**Re: Docket No. 535 — The Towers, LLC — Proposed Wireless Facility at 835 Norwich  
Worcester Turnpike (Route 169), Woodstock, CT**

**Pre-Filed Testimony of Intervenor**  
**Docket No. 535 — The Towers, LLC — Wireless Facility at 835**  
**Norwich Worcester Turnpike (Route 169), Woodstock, CT**

## **Intervenor Exhibit Index — Docket 535 (Proposed Structure)**

Exhibit B: Overview Map of Existing in relationship to the Proposed Docket 535 (Yellow circle 1.5 Miles and Proposed Docket 534 (Green Circle):

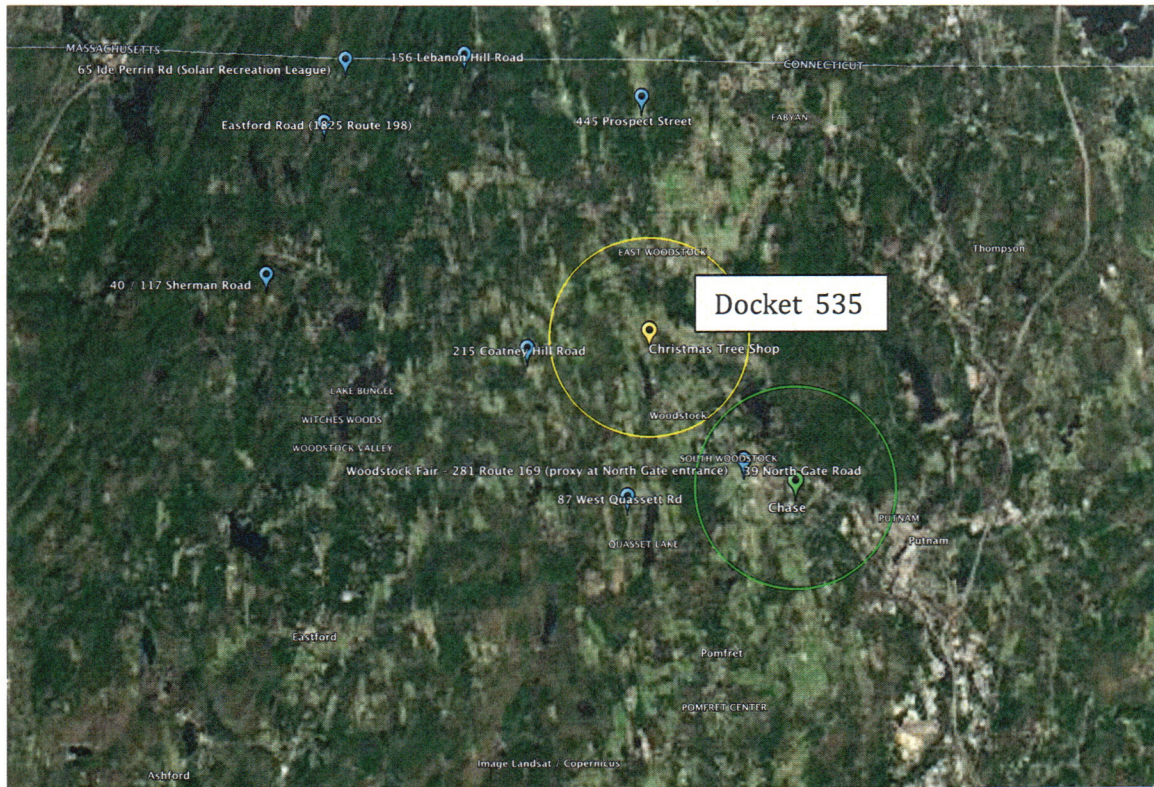
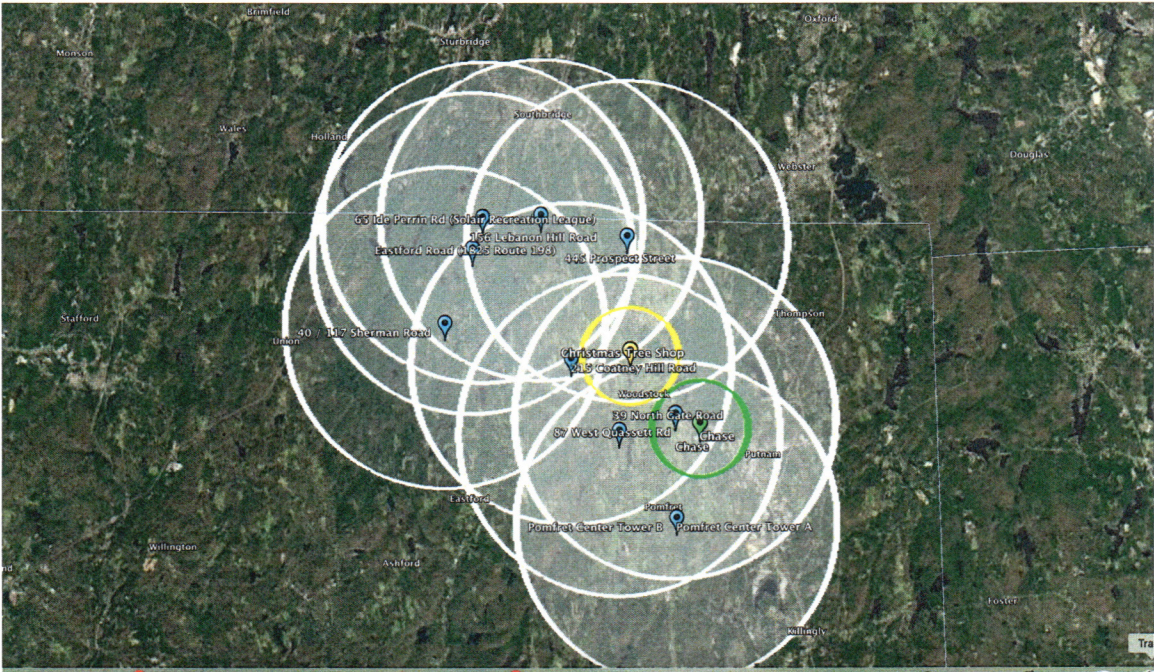
- **Overlapping macro footprints:** Multiple existing macros overlap the site area; adding another 150-ft macro is unlikely to be the least-intrusive remedy for localized performance issues.

- Multiple existing macros overlap the Chase / Christmas Tree Shop areas; Applicant has not shown why collocation, lower heights, or on-parcel relocations would fail technically.

Exhibit C. Existing macros (5-mi translucent) + proposed sites

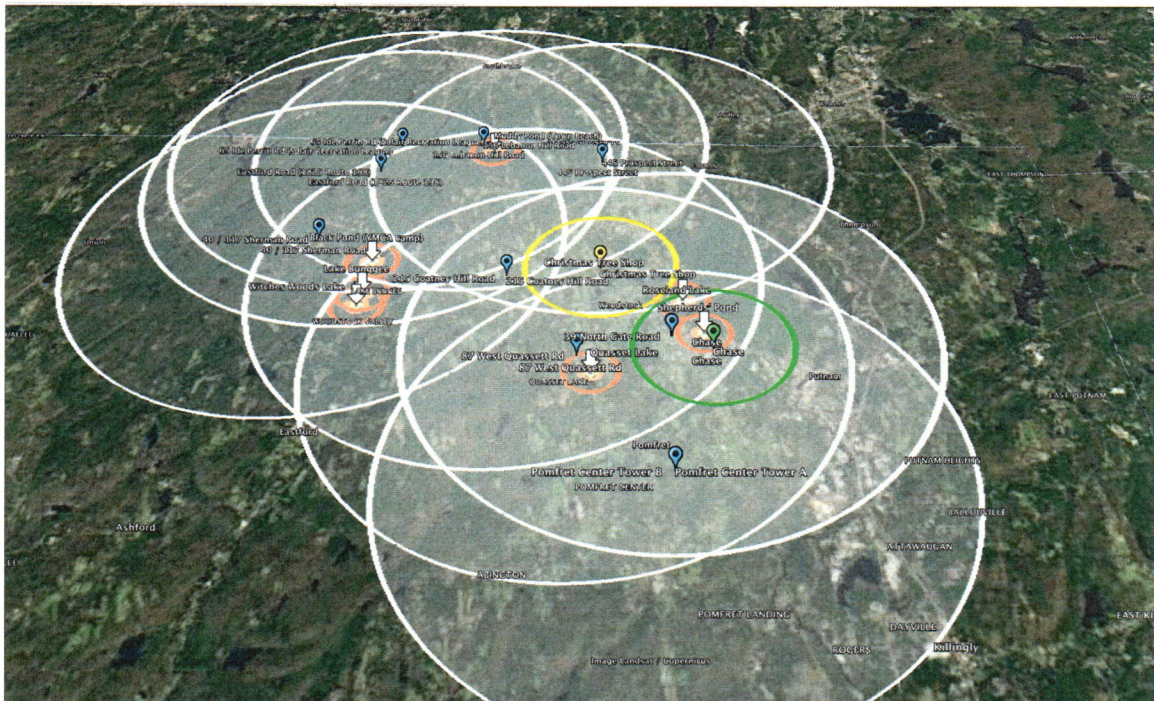
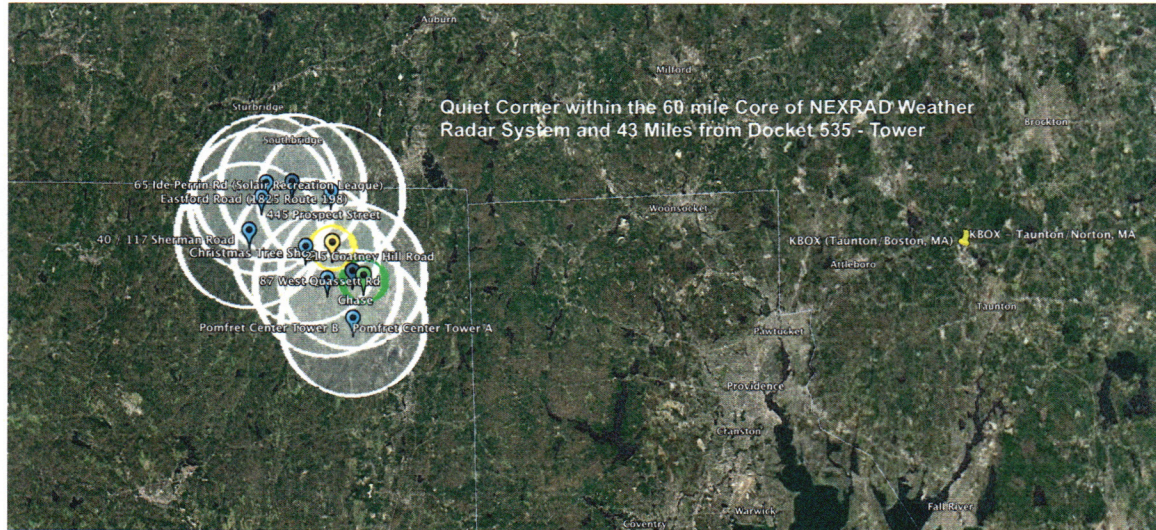
- **Waterways & source-water sensitivity:** Shepherds' Pond and Roseland Lake lie within 2–3 miles; construction stormwater and spill prevention must be robust and verified with local water authorities.

Shepherds' Pond - fed from Roseland into Little River and then Putnam's drinking water. This is lined with homes and people fish and hike along this pond and river source.

Existing macro overlap and proximity to lakes (orange circles.). Yellow and Green Radius 1.5 Miles, all other 5 Miles.
